**NOTICE
OSHTEMO CHARTER TOWNSHIP
Zoning Board of Appeals**

October 17th, 2016

Request: Variance to allow site lighting levels to exceed 0.1 foot-candles at the property line.

Re: Remodel BK# 3568
Burger King Restaurant
5431 West Main Street
Kalamazoo, MI 49009

**Burger King Proposed
Photometric Plan**

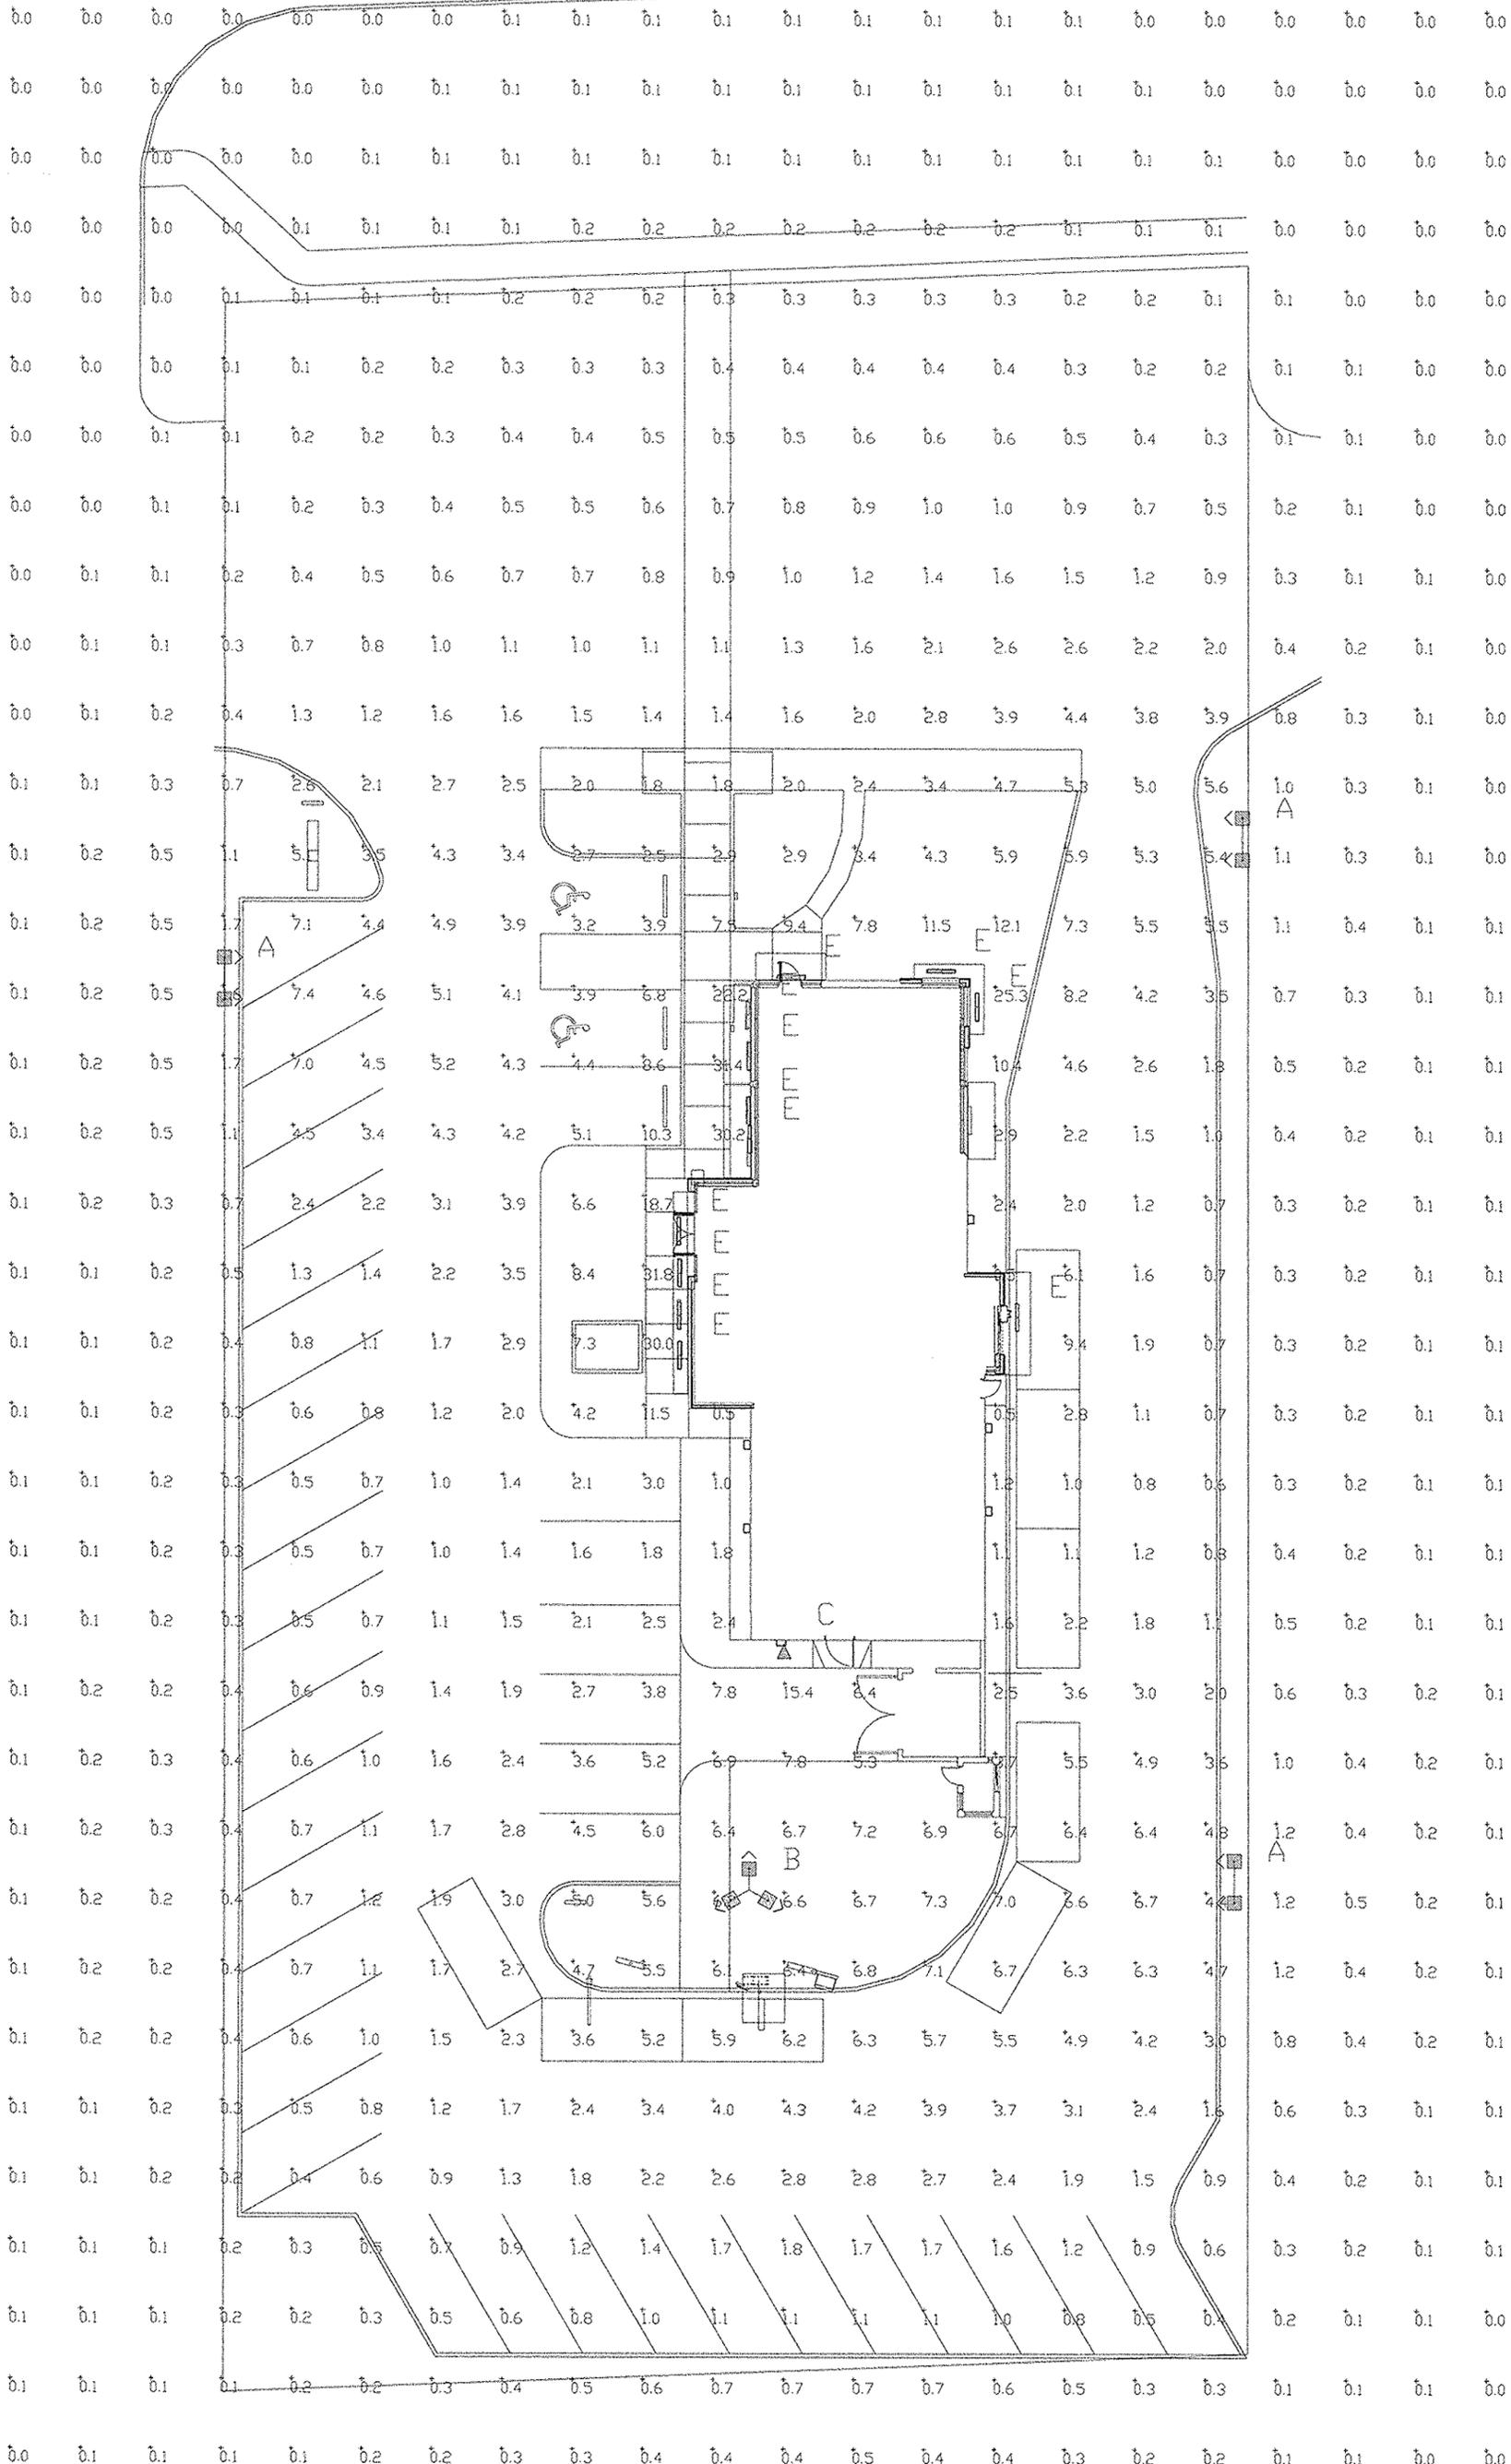
Located on the south side of West Main Street between Drake Road and US 131, the subject property is situated within a busy commercial strip, and all surrounding land is similarly zoned as *C: Local Business District*. As illustrated on the attached proposed photometric plan, light levels at the west property line are not expected to exceed 1.7 foot-candles, while values along the east boundary may be a bit higher. Compared to the recently approved variance for Wendy’s site lighting, the proposed layout for Burger King will be somewhat brighter (by how much is unclear along the east property line due to modelling limitations, but it may be approximately one

additional foot-candle). The applicant has already dimmed the desired site lighting compared to their initial photometric submission to the Township, but further reductions may be possible. Compared to the recently approved Wendy's plan, the proposed Burger King lighting plan indicates between two and three light fixtures per pole, where the former has only one per pole. If Burger King reduced the number of actual fixtures present on each of the poles, lighting levels would be decreased.

While there is precedence established for the granting of relief from the standards of section *78.720 Outdoor Lighting Standards*, especially in situations where the property in question is relatively narrow, the applicant is proposing light levels brighter than what has been allowed in variances granted to similar nearby developments. Therefore, Township staff present three potential options that the ZBA may pursue in this case:

1. Grant the variance as requested, allowing light levels to exceed the typical 0.1 foot-candle limit, per the proposed photometric plan.
2. Grant a variance to the applicant, but require that they submit a revised photometric plan to the Township, clearly indicating that at no point along the property line will light levels exceed 1.2 foot-candles, as was approved on adjacent the Wendy's site.

Based on the criteria for granting a variance and the rationale provided above, staff would recommend approving the same variance provided to the Wendy's site at 5545 West Main Street. This option provides a consistent approach to the spirit of the Ordinance being observed, the public health, safety, and welfare secured, and substantial justice done.
